HIROSE ELECTRIC CO., LTD.
2-6-3 Nakagawa Chuoh, Tsuzuki-ku, Yokohama, JAPAN**HIF3 Series Crimp Terminals – Product Consolidation**

■Product list PCN2026-06_HIF3 Series Crimp Terminals – Product Consolidation

[Change Details] HIF3 Crimp Terminals

Differences Before and After Change (Reel Terminals)

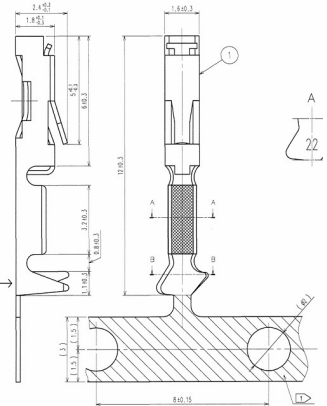
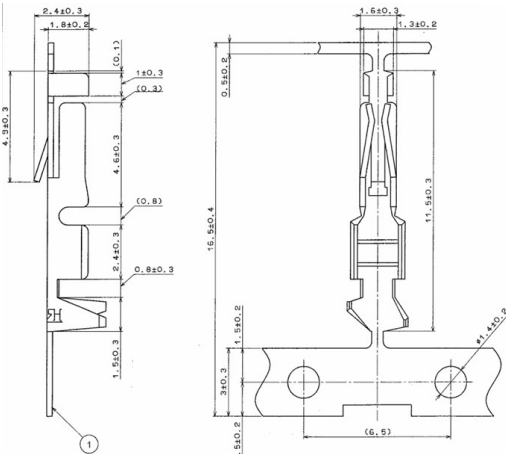
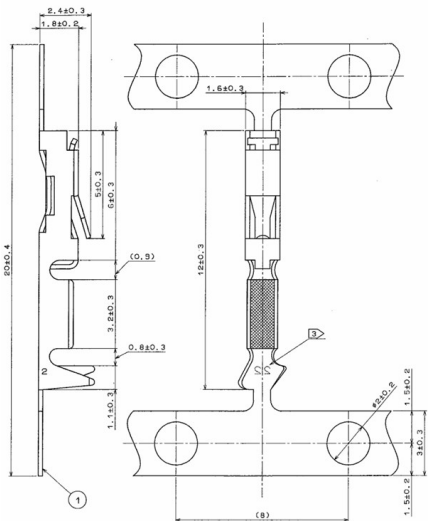
Type	Main Features
HIF3-***SCF 	• Full gold plating 0.2μm • 2-point contact (Top-bottom clamping) • Single-side carrier
HIF3-***SCFC 	• Partial gold plating 0.2μm • 2-point contact (Left-right clamping) • Double-side carrier

Type	Main Features
HIF3-***SCFA 	• Partial gold plating 0.2μm • 2-point contact (Top-bottom clamping) • Double-side carrier

Differences Before and After Change (Applicator)

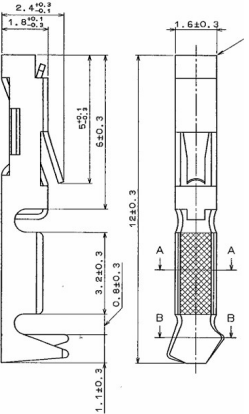
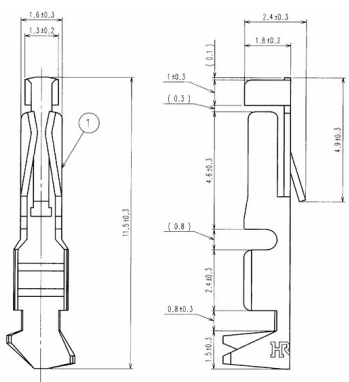
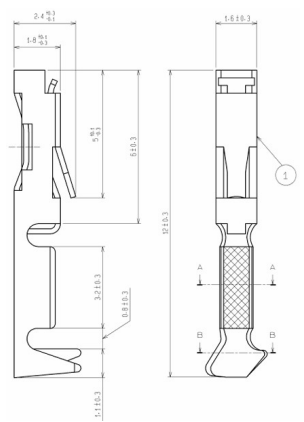
Product	Applicator	Applicator CL	Remarks
HIF3-2022SCF	AP105-HIF3-2022S	CL0901-4027-9	Modifications supported
HIF3-2226SCF	AP105-HIF3-22-28SCF	CL0901-4031-6	Modifications supported
HIF3-2428SCF			
HIF3-2226SCFC	AP105-HIF3-2226SCFC	CL0901-4005-6	Modifications not supported
HIF3-2226SCF(11)

Since Partial plating products have carriers on Double sides, they cannot be crimped with your current applicator. We will perform the modification work, so please contact your Hirose sales representative.

Alternative product	Applicator	Applicator CL	Remarks
HIF3-2022SCFA	AP105-HIF3-2022SA	CL0901-3512-0	-
HIF3-2226SCFA	AP105-HIF3-22-28SCFA	CL0901-4030-3	-
HIF3-2428SCFA			-
HIF3-2226SCFA	AP105-HIF3-22-28SCFA	CL0901-4030-3	-
HIF3-2226SCFA			-
